ARDEN HILLS  
MEMORANDUM

PC Agenda Item **3.B**

**SUBJECT:** Planning Case # 19-001 – **Public Hearing Required**  
Applicant: Brausen Family Automotive Repair  
Property Location: 1310 W County Road E  
Request: Site Plan Review; Final Planned Unit Development

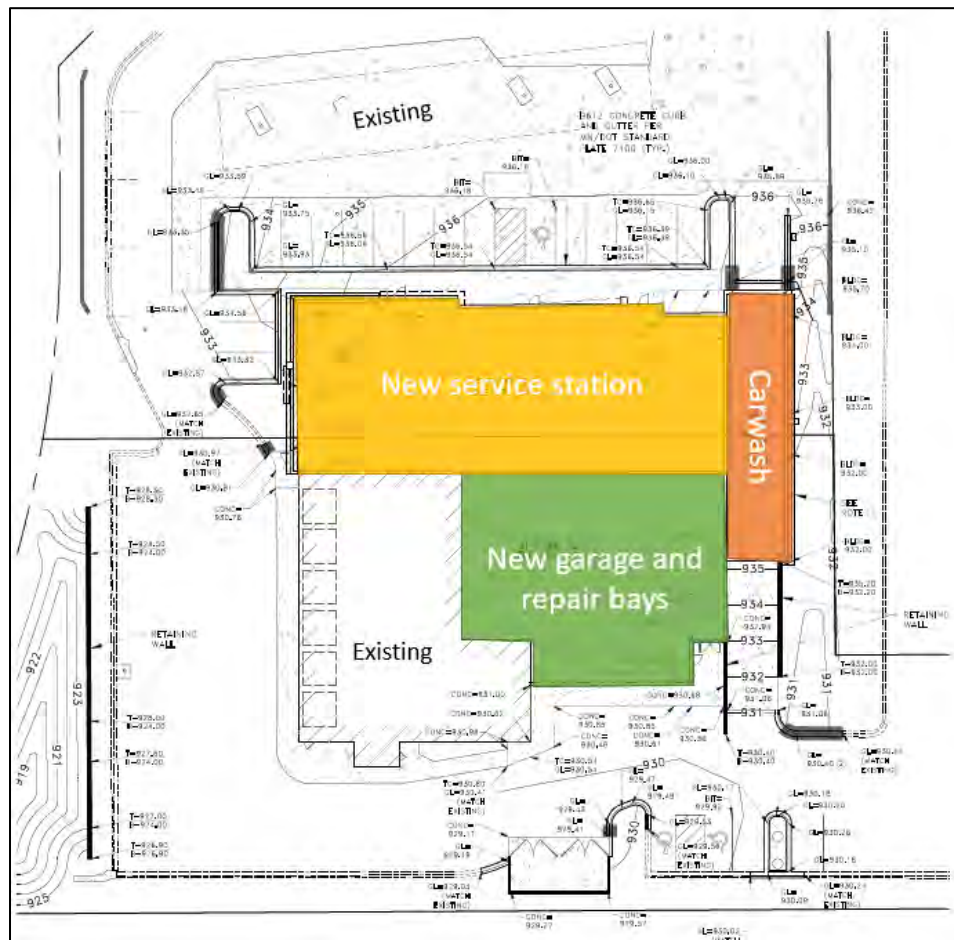
In addition, the applicant is proposing a 4,505 square feet garage and repair bay addition. The proposed addition is highlighted on the image above. The proposed addition will add six (6) additional repair bays. The existing garage, which is about 4,540 square feet, will remain, as will the existing fuel islands and canopy. However, the façade of the existing garage will be updated as part of this application. The Applicant is not proposing any modification to the existing accesses on County Road E.
